DRAWING AMENDMENTS

Changes have been made to Figs. 1, 3, and 5.

Attachments:        Three Replacement Sheets  
                         Three Annotated Sheets Showing Changes

FIG. 1

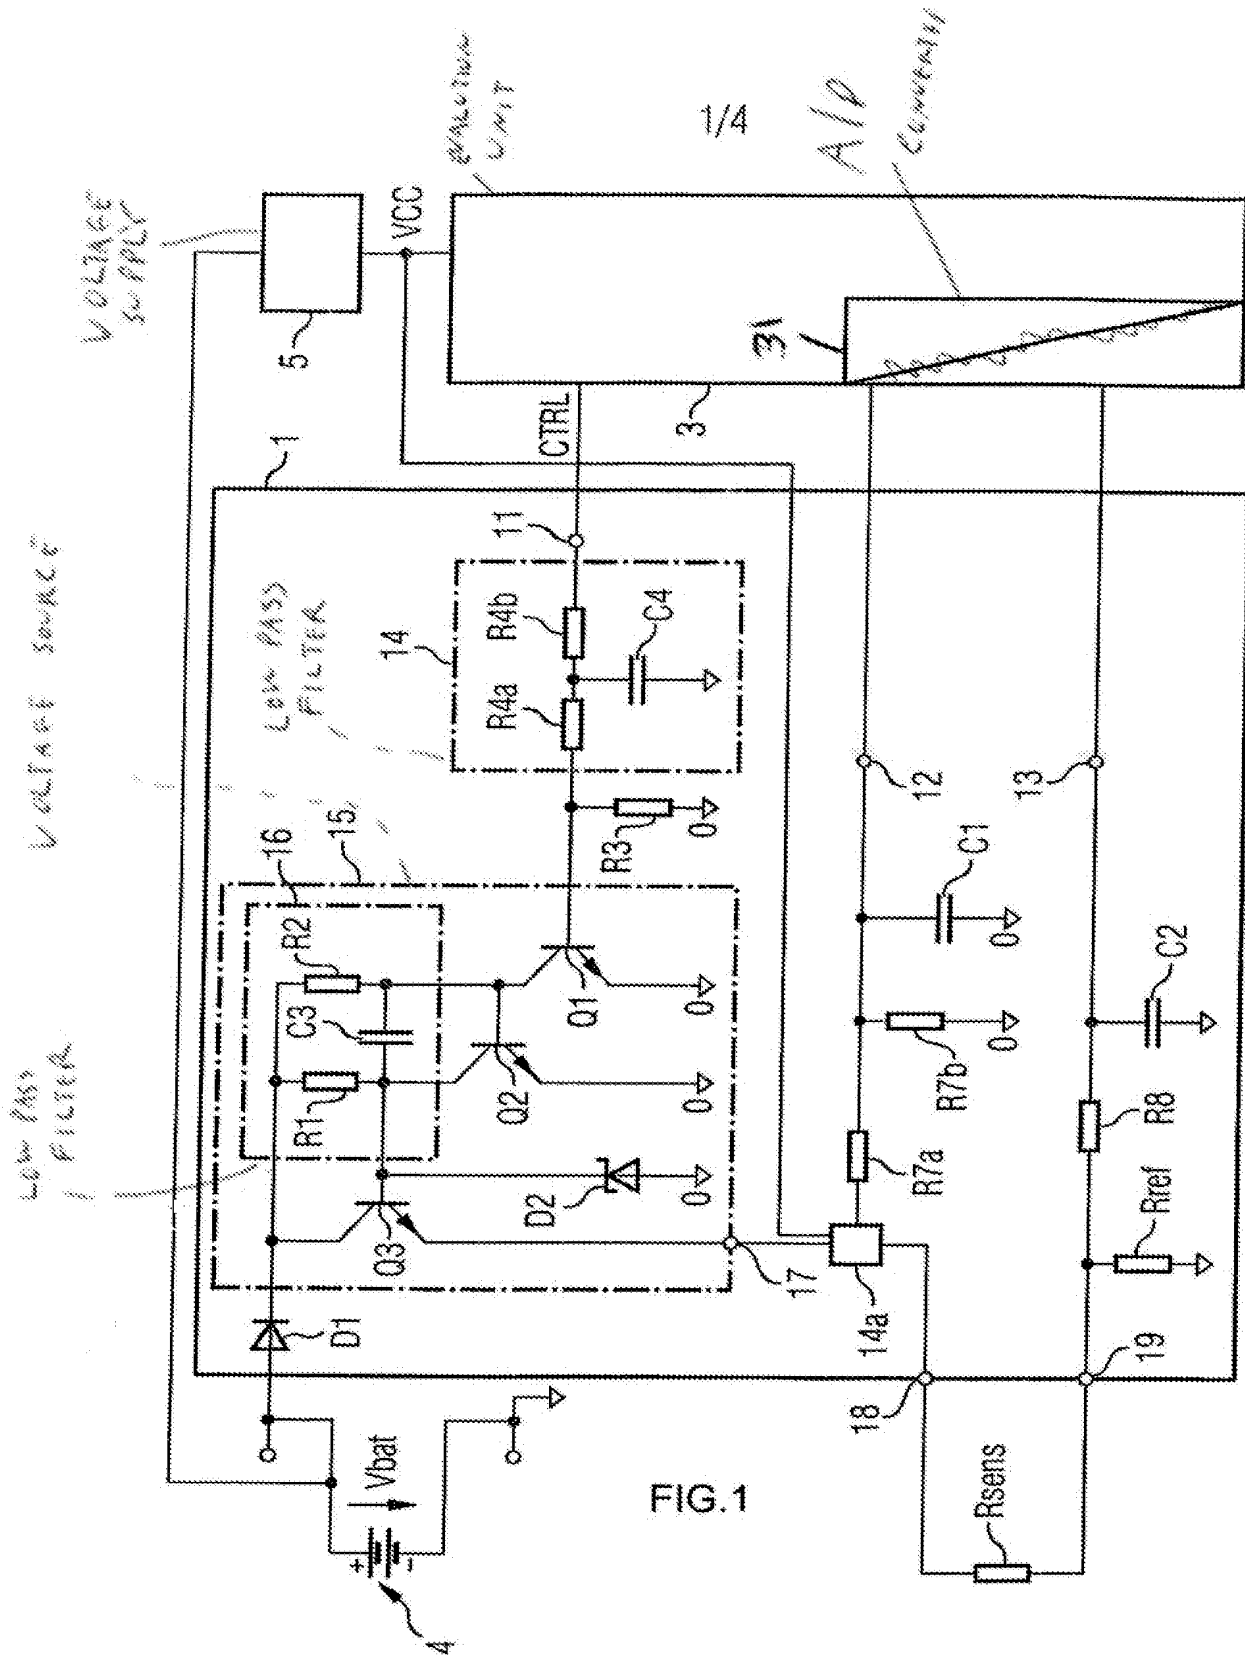
Under the heading "Drawings" on page 2 of the above-identified Office Action, the Examiner objected to the drawings because they did not include reference number 31 associated with the analog to digital converter described in the specification.

Reference numeral 31 has been associated with the analog to digital converter in Fig. 1.

FIG.3

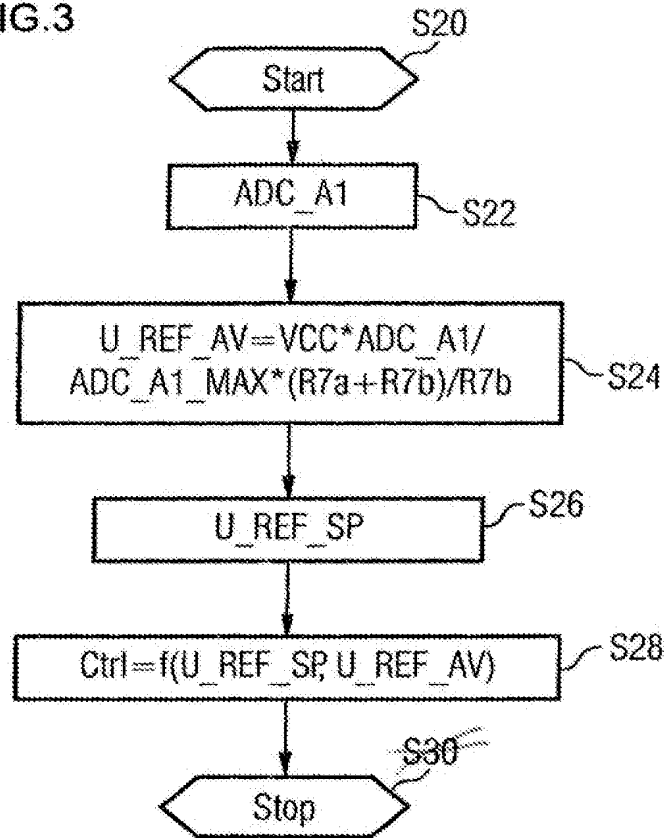
Under the heading "Drawings" on page 2 of the above-identified Office Action, the Examiner objected to the drawings because they include reference character S30 which is not mentioned in the specification.

Reference character S30 has been deleted from Fig. 3.

FIG. 5

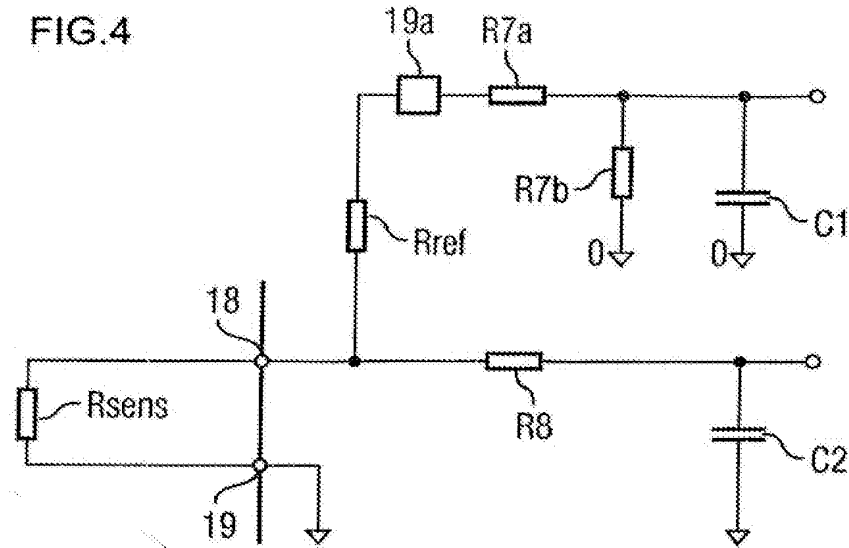
Under the heading "Drawings" on page 3 of the above-identified Office Action, the Examiner objected to the drawings because the vertical ordinates of Fig. 5 had not been labeled.

The vertical ordinate on the left side of Fig. 5 has been labeled as current with respect to curve 92 and as power with respect to curves 93 and 94. The vertical ordinate on the right side of Fig. 5 has been labeled as power with respect to curve 91.
